Chevron U.S.A. Products Company

Re: Chevron Service Station No. 9-3356

19201 Center Street, Castro Valley, CA 94546

MONITORING WELL CONSTRUCTION DETAIL

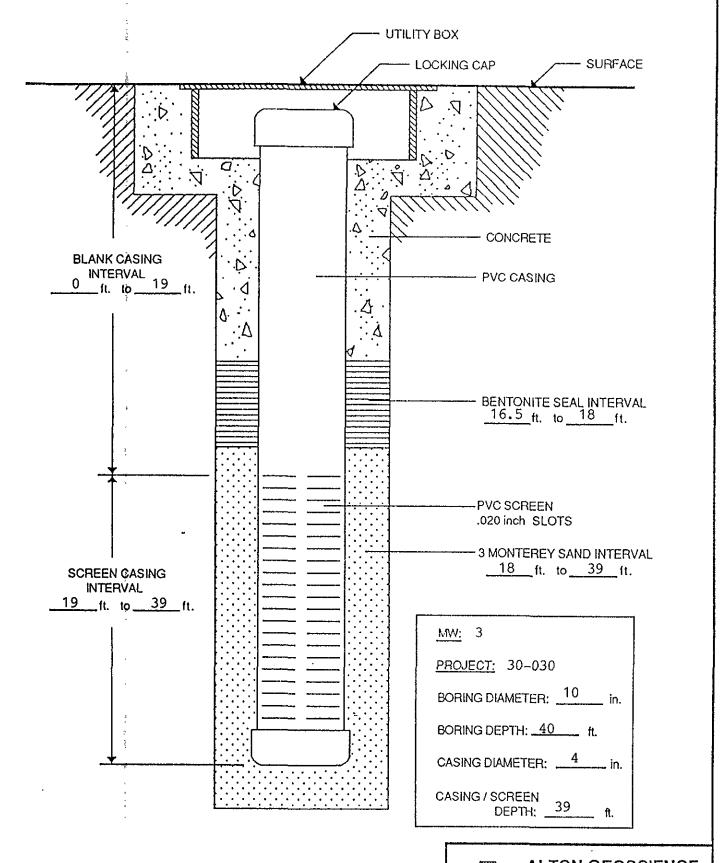
There appears to be a reasonable explanation why Alton Geoscience screened monitoring well MW-3 from 19 to 39 feet. When Alton was drilling B-3 (MW-3), they encountered a damp to saturated layer of soil between 5 and 15 feet. Beyond 15 feet, they encountered only dry soil. They probably made three assumptions. First, they probably assumed the soil at 10 feet was perched groundwater. Second, they probably assumed the depth to water at this location was similar to B-1 (MW-1), and third, they probably assumed the saturated layer of soil did not go beyond 17.5 feet. Because they did not want the perched water to influence the monitoring well, they probably decided to screen the well between the last sample that was damp (15 ft.) and the first sample that was dry (20 ft.). Hopefully, this explanation answers your question.
